Re: 1346 San Lorenzo Ave NW – Sketch Plat
Case No. 1008250

DEVELOPMENT REVIEW BOARD – SPEED MEMO

DRB CASE NO: 1008250

CITY OF ALBUQUERQUE
PLANNING DEPARTMENT
March 31, 2010
DRB Comments

SITE PLAN

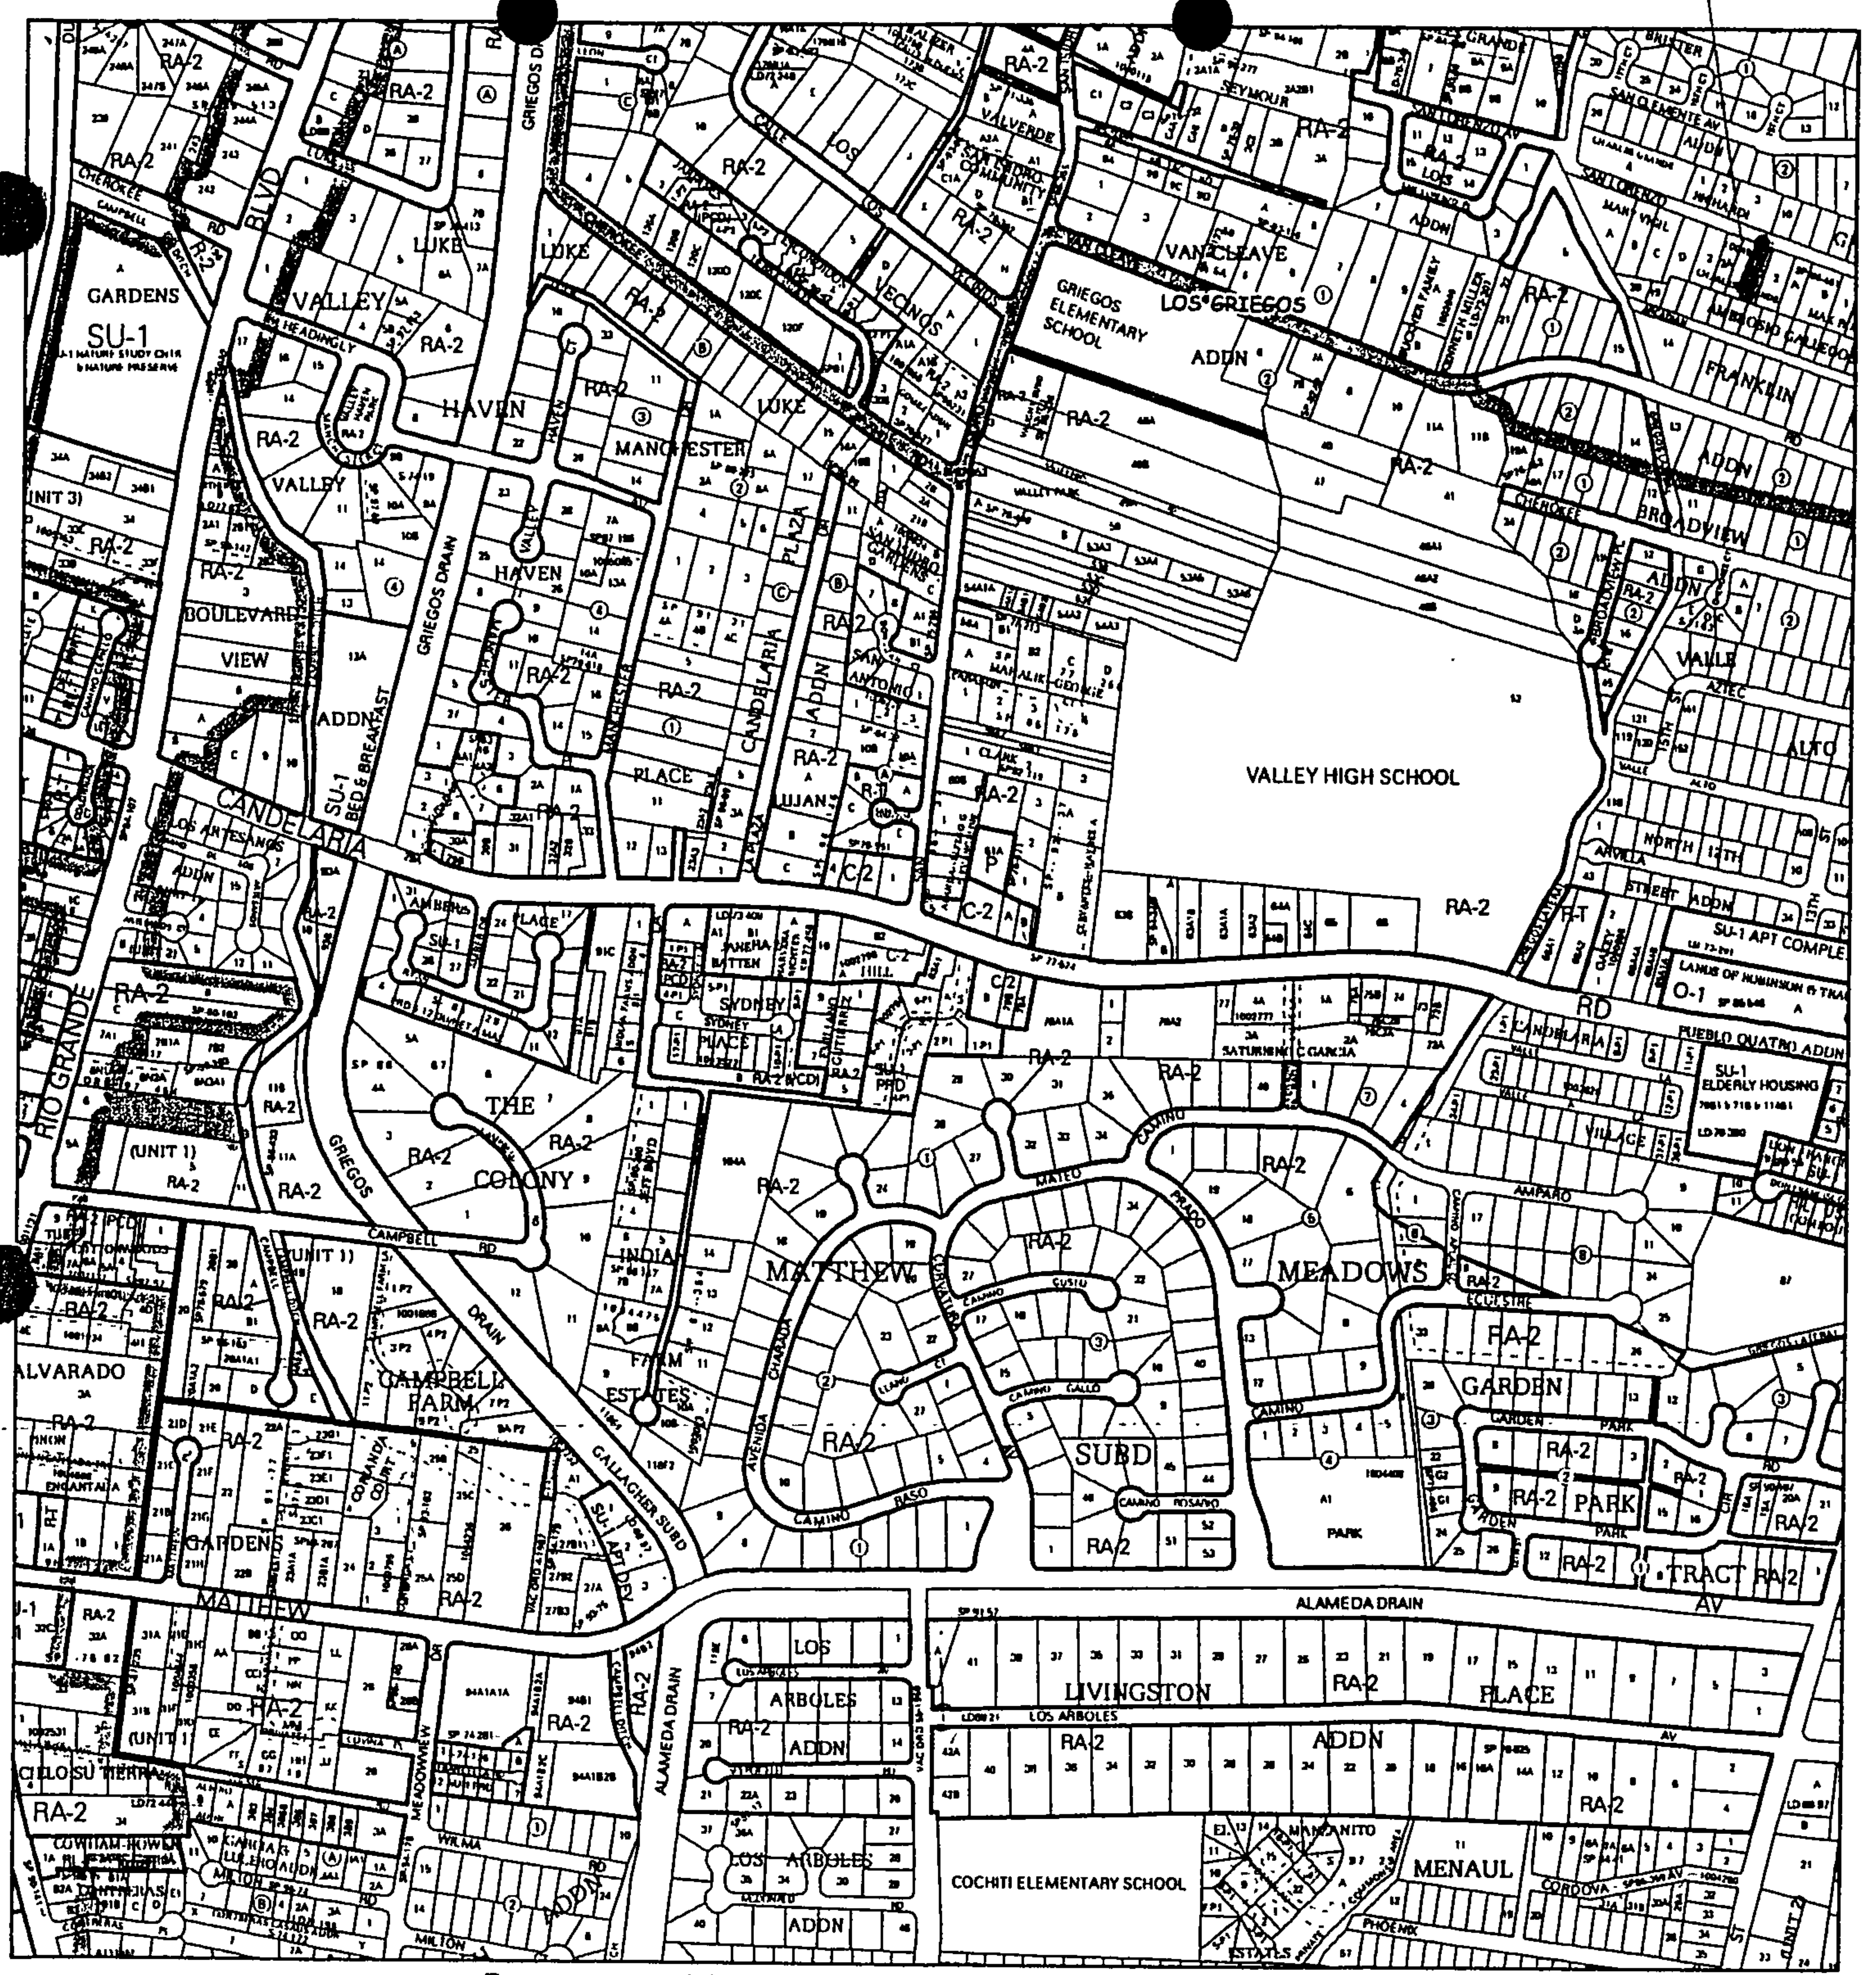
- 1) Provide an exhibit showing the location of the sidewalk and defining the distance from the face of curb to the property line. *REVISED SKETCH PLAT ATTACHED*
- 2) Provide exhibit showing private utility easement. *REVISED SKETCH PLAT ATTACHED*
- 3) Justification needed to demonstrate that there is NOT a pattern of larger developed lots which constitute the established character of the neighborhood. *Please see attached Zoning Atlas of the neighborhood which indicates the neighborhood contains lots of various square footage and lacks any clear and consistent pattern in regard to size. For example the lots facing Arcadia that share a property line with the lots facing San Lorenzo range in size from 5,266 sq ft to 5,362 sq ft. The lot at the corner of Grande and Trinity (#42) is 3,047 sq ft. Lots on San Clemente range in size from 5,026 to 5,540 sq ft.*

Provide an exhibit showing the location of sidewalk and defining the distance from face of curb to the property line. Right of way dedication may be required.

+ private utility easement for drainage to street

SITE PLAN

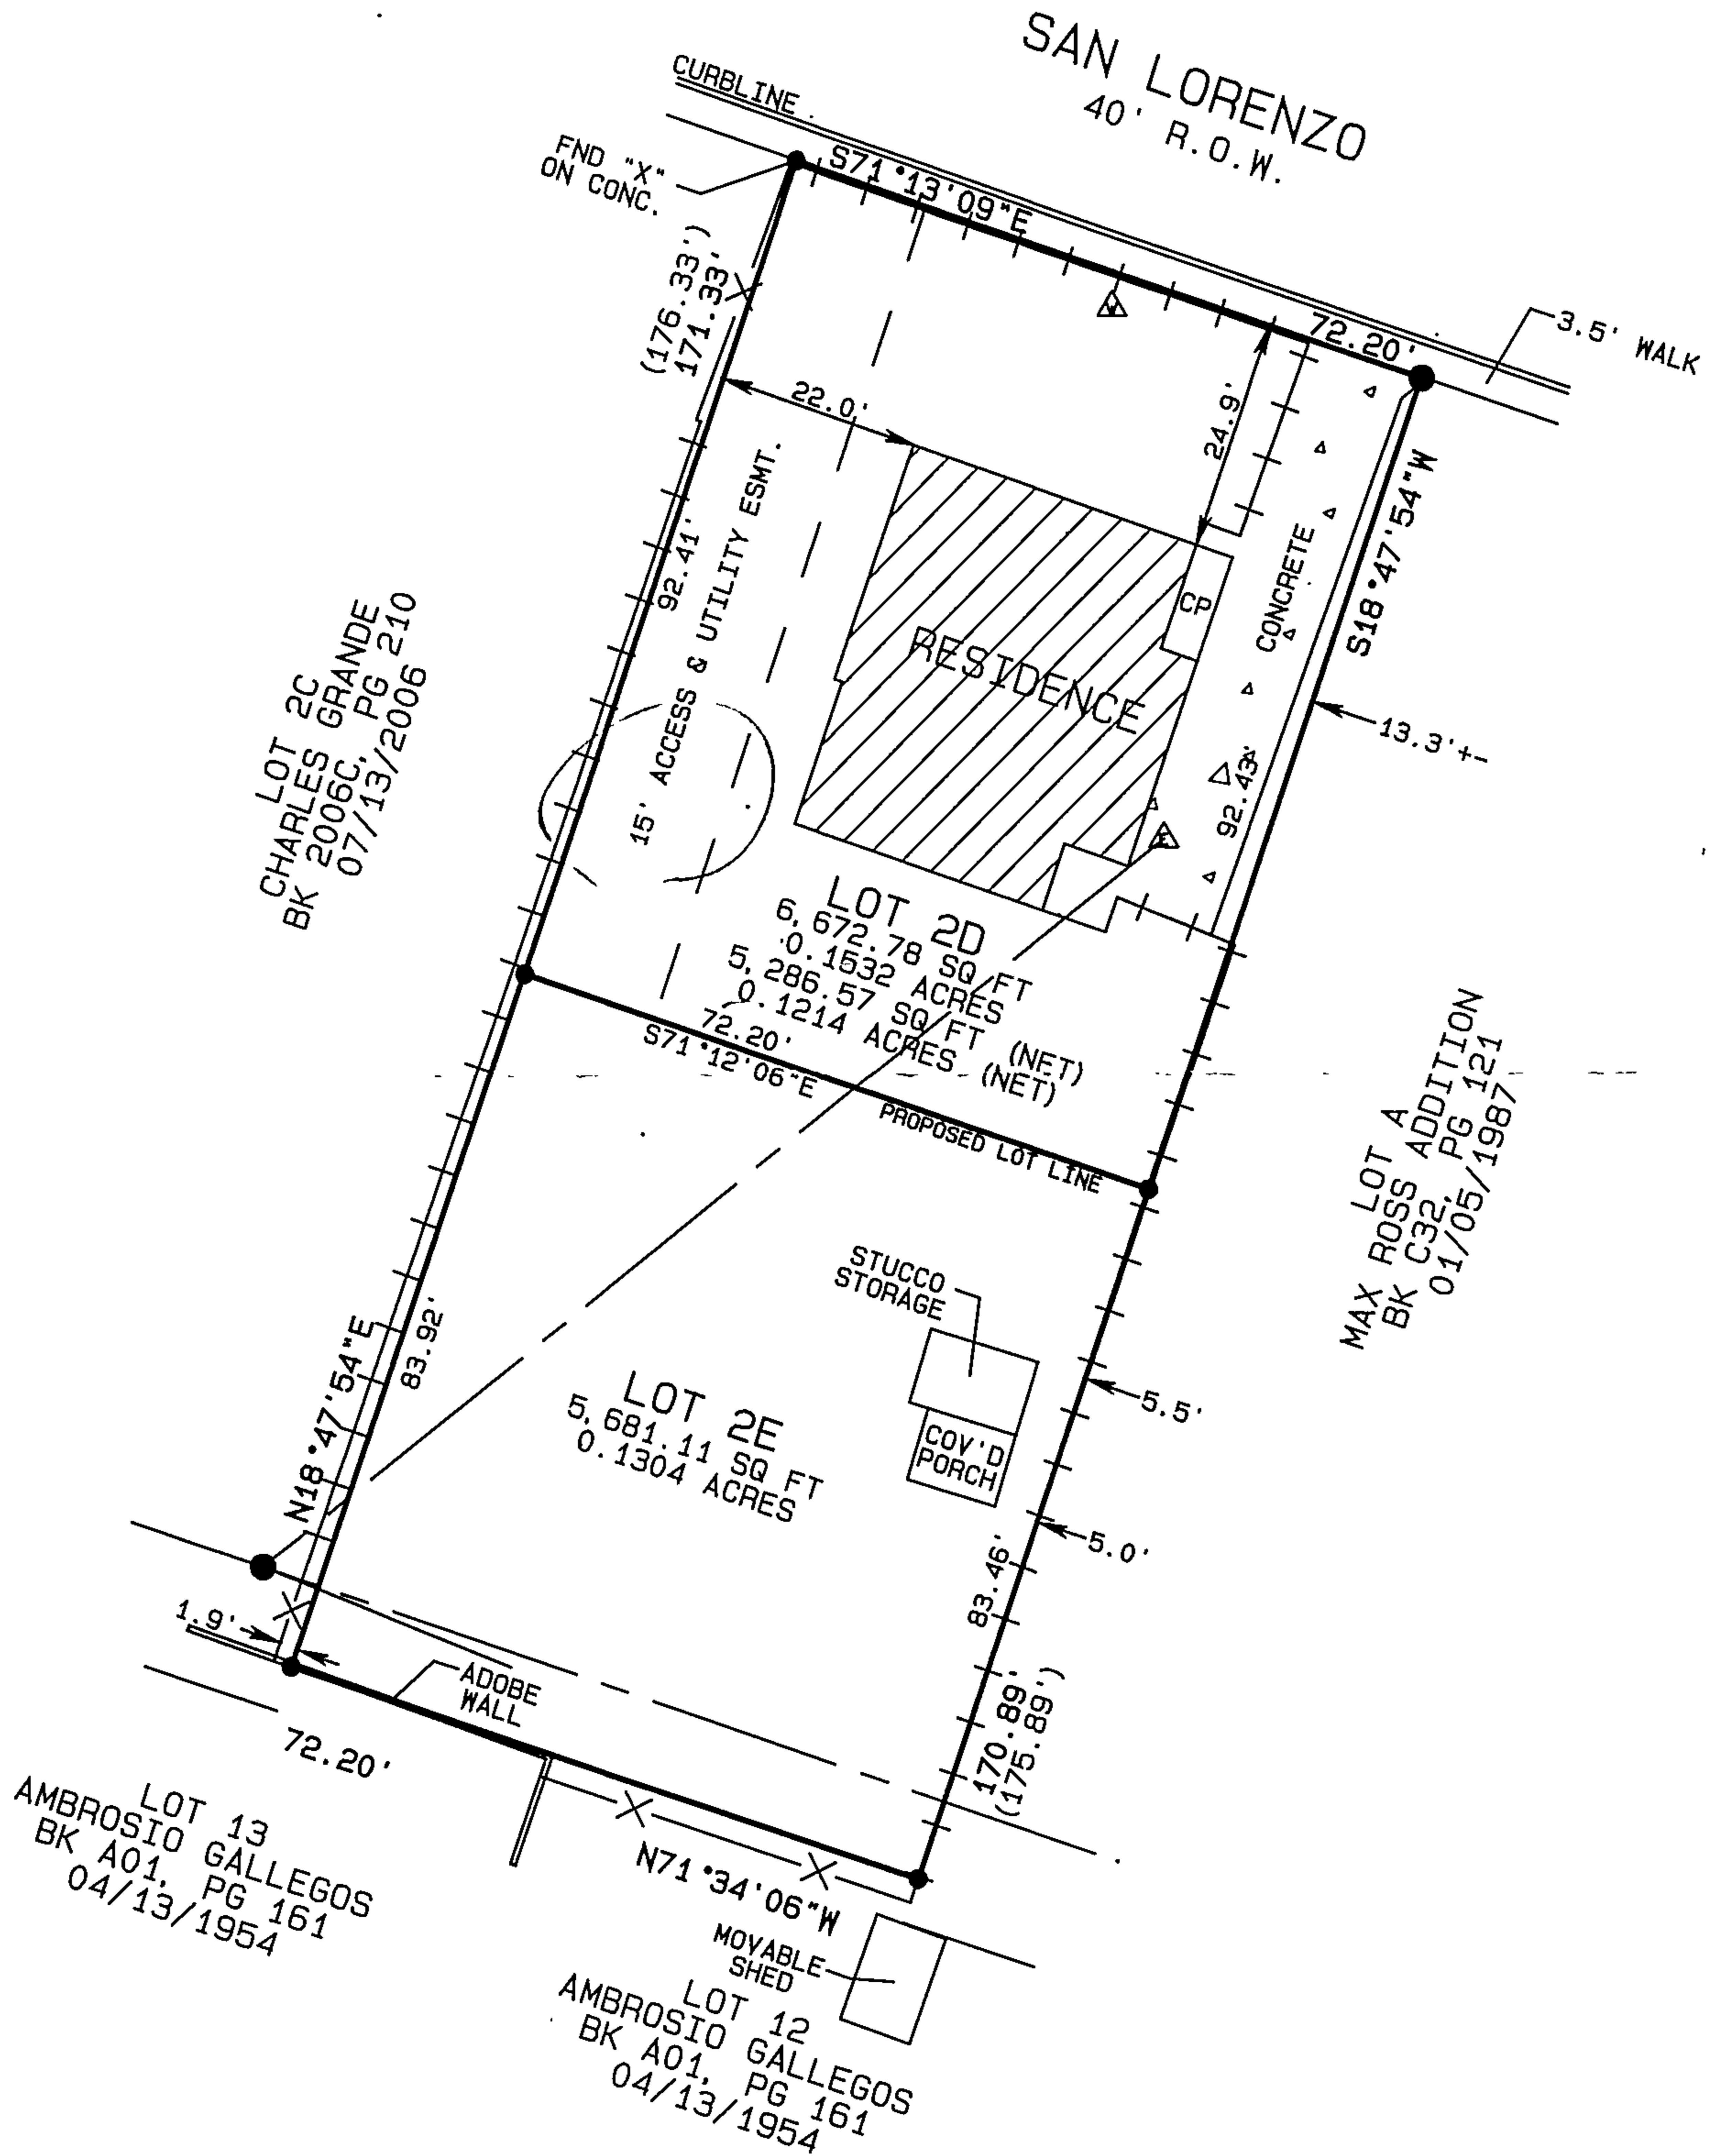
It appears a lot size variance may be needed – the minimum net lot area of 5,000 sq ft in an R-1 Zoning District is allowed “only where the Planning Director finds that such a lot size will not depart from a pattern of larger developed lots, which pattern constitutes the established character of the neighborhood.” [§ 14-16-2-6(D)(2) b)]

Additional justification would be needed, to demonstrate that there is NOT a pattern of larger developed lots which ‘constitute the established character of the neighborhood,’ e.g. the Gallegos-Ambrosio Subdivision on Arcadian Trail NW, and the Brister Stripe Addition on San Clemente Avenue NW, Trinity Square Subdivision, etc.
